UNITED STATES PATENT AND TRADEMARK OFFICE

APPLICATION NO.	FILING DATE	FIRST NAMED INVENTOR	ATTORNEY DOCKET NO.	CONFIRMATION NO.
10/004,758	12/04/2001	Donald J. Monroe	10541-636	8286
29074	7590	08/18/2004	EXAMINER	
VISTEON C/O BRINKS HOFER GILSON & LIONE PO BOX 10395 CHICAGO, IL 60610			RODRIGUEZ, PAMELA	
			ART UNIT	PAPER NUMBER
			3683

Office Action Summary

DETAILED ACTION

Fig. 1

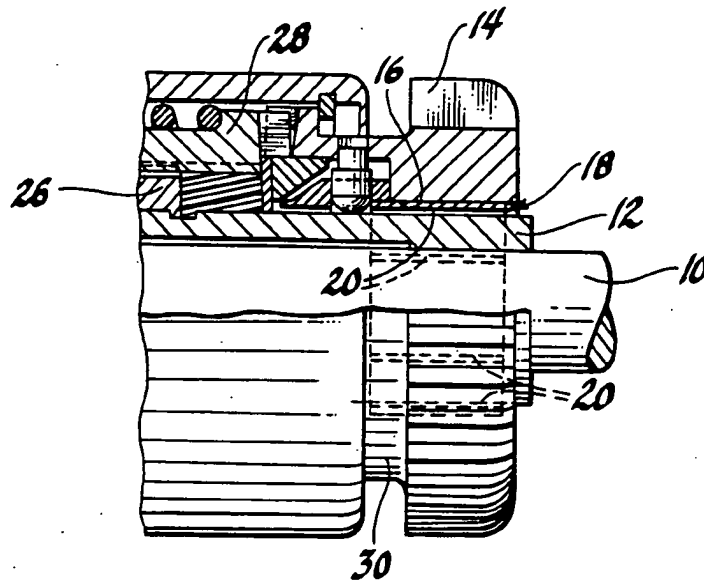
Regarding Claim 1, Johnston discloses a pinion 14/18 moveable along an output shaft 10 of a starter assembly (see Figures 1 and 2) having all the features of the instant invention including: the pinion 14/18 having an inner surface 24 disposed about the output shaft 10 (see the attached labeled Figures 1 and 2 of Johnston and the inner surface portion indicated therein, wherein

since bushing 18 is integral with pinion 14, the inner surface is readable as the inner surface 24 of pinion bushing 18), the inner surface terminating at an end face of the pinion 14/18 (see the examiner's attached labeled Figures 1 and 2 of the Johnston reference depicting the inner surface and the end face as she now interprets them), wherein the inner surface and the end face are perpendicular with each other and define a secondary edge (see the examiner's attached labeled Figures 1 and 2 of Johnston, where the secondary edge is the pink highlighted portion of the figure where the inner surface and end face meet), wherein the pinion 14/18 comprises a primary edge (see Figure 2 and the middle groove 20, wherein the primary edge is readable as the right top edge of that groove nearest the top lead line of element numeral 24) for moving particles from the shaft 10 as the pinion 14/18 moves along the output shaft (see column 3 lines 6-13), the primary edge being formed along a length of the inner surface (see Figure 2) and extending to the end face 22 (see Figure 2), the primary edge defining a groove 20 in which the particles are received as the pinion 14/18 moves along the output shaft (see column 3 lines 6-13), and wherein the groove 20 is formed along the length of the inner surface 24 and adjacent the primary edge (see Figure 2).

Regarding Claim 14, see the barrel portion shown in Figure 1 and a gear portion (see Figure 1 and the portion of pinion 14/18 labeled element numeral 14), wherein the end face and the inner surface 24 are adjacent the gear portion (see Figures 1 and 2).

Fig. 2

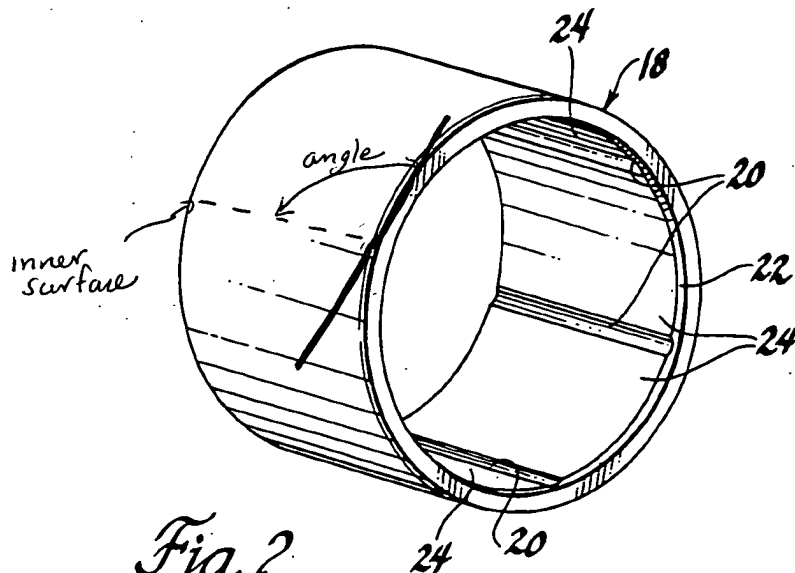
Regarding Claim 5, Johnston further discloses a secondary edge for moving the particles from the primary edge, the secondary edge being defined at the juncture of the end face and the inner surface and being configured to move the particles from the shaft (see the examiner's attached labeled Figures).

Regarding Claim 7, see Figure 2.

Regarding Claim 9, see the plurality of grooves 20 on the inner surface 24 shown in Figure 2 and note how each groove has its own separate primary edge as described in Claim 1 above.

Regarding Claim 10, see grooves 20 in Figure 2, each formed along the length of the inner surface 24 and adjacent each respective primary edge.

the secondary edge would be at least slightly less or equal to 90 degrees (see the examiner's labeled figures).
